CERTIFICATE OF APPROPRIATENESS

This letter provides you with results of review for the proposed corrective work submitted on June 9, 2021 to your designated Fort Collins landmark property, the Long Apartments at 220 E. Laurel Street. This work is intended to correct work denied by the Historic Preservation Commission (then the Landmark Preservation Commission) at their March 17, 2021 meeting. Work denied that required corrective action included:

ALTERNATE | EXTERIOR SELECTIONS

OBERMANN RESIDENCE
220 E LAUREL STREET

NEW SELECTION
Rejuvenation Pittock Sconce
Aged Brass | Opal

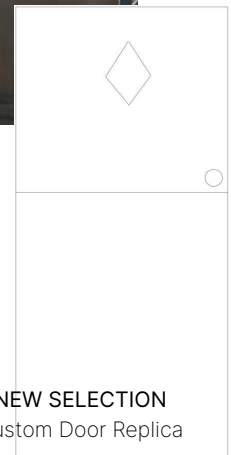
- 1) Re-establishment of entry door with matching replacement
- 2) Replacement of front stoop tile cladding to match historic images
- 3) Replacement sconce on front of the building (Action not required under Commission decision)

These corrective work items have been approved by the City's Historic Preservation Services Division because the proposed work meets the criteria and standards in Chapter 14, [Article IV](#) of the Fort Collins Municipal Code. Because this work is corrective based on the March 17, 2021 Commission meeting, once work is complete, please contact City Preservation staff to schedule a time to complete a short site visit so staff can confirm executed work meets the Standards to close out this item.
